Accelerating the transition to a net-zero, nature-positive economy in Chile

Review CEO Endorsement and Make a recommendation

GEF ID

11088
Countries

FIGURE 2 CHILE'S GHG BALANCE (KT CO2 EQ) BY SECTOR (1990 - 2020)

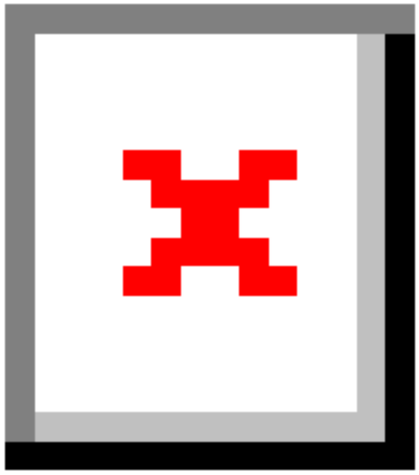
Also, since the Portal View of the CEO Endorsement is the document that will be published in the GEF website, kindly remove all the yellow highlights and make sure the following figures are properly shown in the document (see also below): Figure 2 Chile GHG Balance by Sector, Figure 4 Terrestrial Ecosystem Conservation, page 17, Problem Tree in page 37 and page 120. See example of Figure 2 below.

FIGURE 2 CHILE'S GHG BALANCE (KT CO2 EQ) BY SECTOR (1990 - 2020)

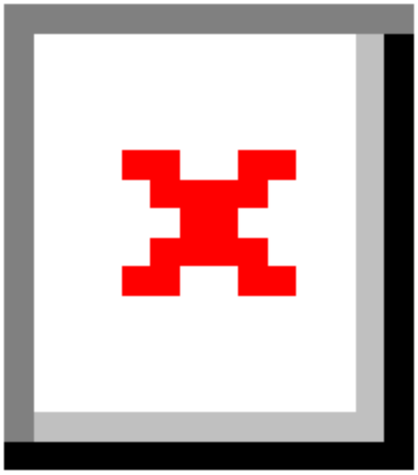
Not Cleared yet. Please address remaining comments above. Also, in the Portal View of the CEO Endorsement document remove all highlights and make sure the following figures are readable: Figure 2 Chile GHG Balance by Sector, Figure 4 Terrestrial Ecosystem Conservation, Problem Tree in page 37 and Annex E. See example of Figure 2 below.
